# 1998 - 1999 Corvette: Service Bulletin: Tech - Service Engine Soon (SES) Light Illuminates (Repl Switch Assy)

**Source:** Chevrolet Dealer Technical Service Bulletin

**Number:** 99-07-30-013

with Hydra-Matic 4L60-E Transmission (RPO M30)

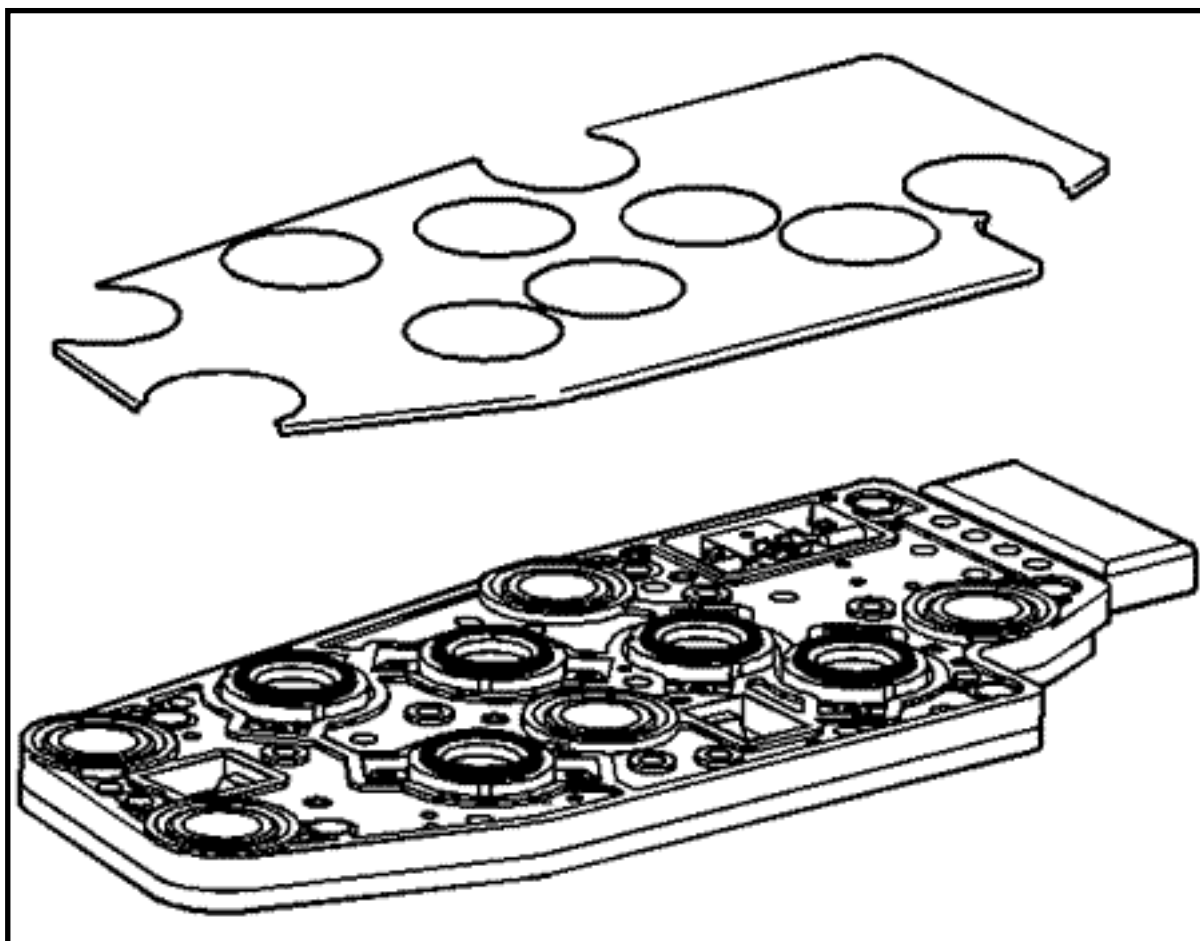
Debris from aluminum shavings, bronze material, and certain clutch material may cause the pressure switches in the TFP switch assembly to stick or electrically short out.

A new TFP switch assembly with a plastic shield has been released. The plastic shield is designed to protect the pressure switch from debris. This improvement will reduce the likelihood of a DTC P1810. This product change went into production on April 8, 1999 (Julian date 098). The existing TFP switch assembly remains relatively unchanged except for the addition of the new shield, creating a new part number for the assembly. The shield fits over the existing TFP switch assembly and is not sold separately.

Follow diagnostics for the P1810 Diagnostic Trouble Code in the Transmission Section of the appropriate Service Manual. If the diagnostics indicate that switch replacement is necessary, use the correct switch P/N as listed below.

Part Number	Usage	Description
24215111	1998-1999	TFP Switch Assembly with Shield
